REQ. PER. UNIT	USED ON			RL 124 D
	MODEL	ASS'Y. NO.	DATE	
Z	GPT 10K	RELAY/PANEL	5-11-59

SPECIFICATIONS

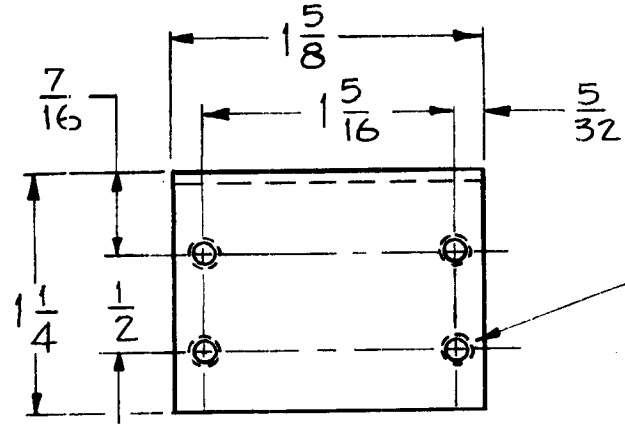
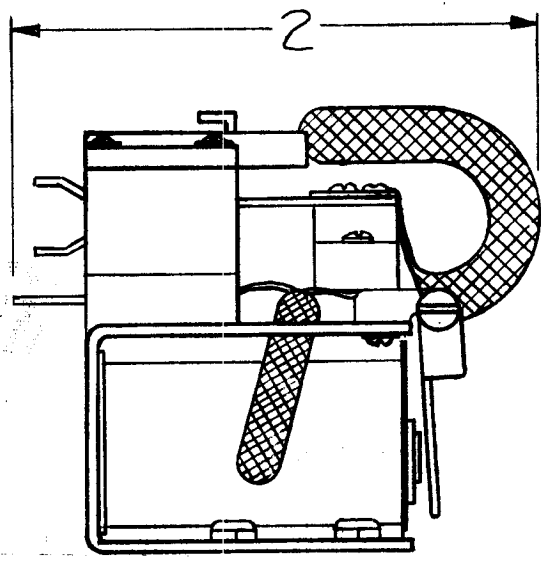
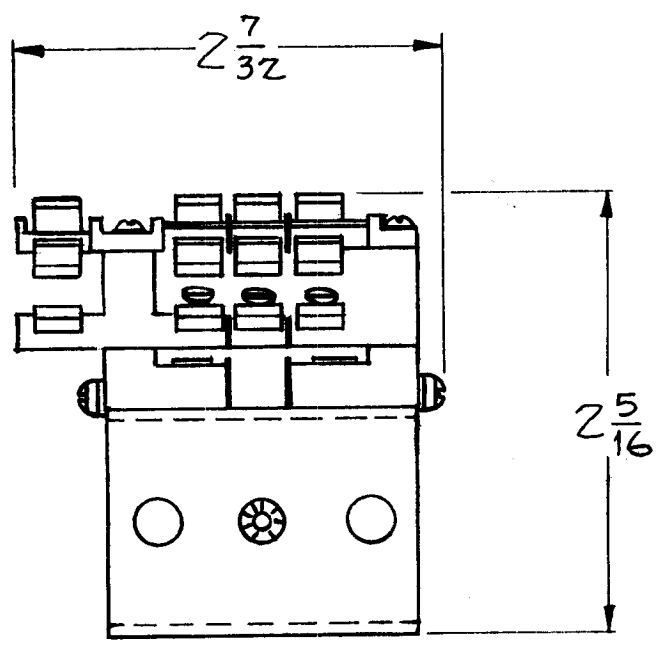
REQ.	ITEM	PART NO.	DESCRIPTION		SYMBOL				
D	5401-439 WAS 401-59	1030 85	GDL						
C	ADJ. SPECS. 5% ADDED	4.15.64	11214	NB	<i>[Signature]</i>				
B	IN SPECS. 1150 OHMS WAS 1800 OHMS	11/4/63	10326	<i>[Signature]</i>	<i>[Signature]</i>				
A	ON ELEC. SPEC. "PULL IN VOLTAGE 175V AC" ADDED	9/12/63	9913	G.D.L.	<i>[Signature]</i>				
ISSUE	ITEM	CHANGED FROM	DATE	CH. NO.	DRAFTS	CHECKER	ENG. APP.		
TOLERANCES		SCALE: S-401-439-93 AX 13							
DEC. DIM. ±		MAXIMUM ALLOWABLE TOLERANCES HAVE BEEN DETERMINED AND ANY DEVIATIONS WILL BE CAUSE FOR REJECTION. REMOVE ALL BURRS AND SHARP EDGES							
FRAC. DIM. ±									
ANGULAR DIM. ±									
TYPE & TEMPER		HEAT TREAT. SPEC.		DRAWN		CHECKED		FINAL APPROVAL	
FINISH & SPEC. NO.		ELEC. DES. APP.		MECH. DES. APP.		RL 124 D

COIL - 1150 OHMS ± 10%
 MOISTURE RESISTANT
 VARNISHED.

ADJUSTMENT ~ OPERATE
 220V, 50/60 CYCLE AC.
 PULL IN VOLTAGE 175V ± 5% AC.
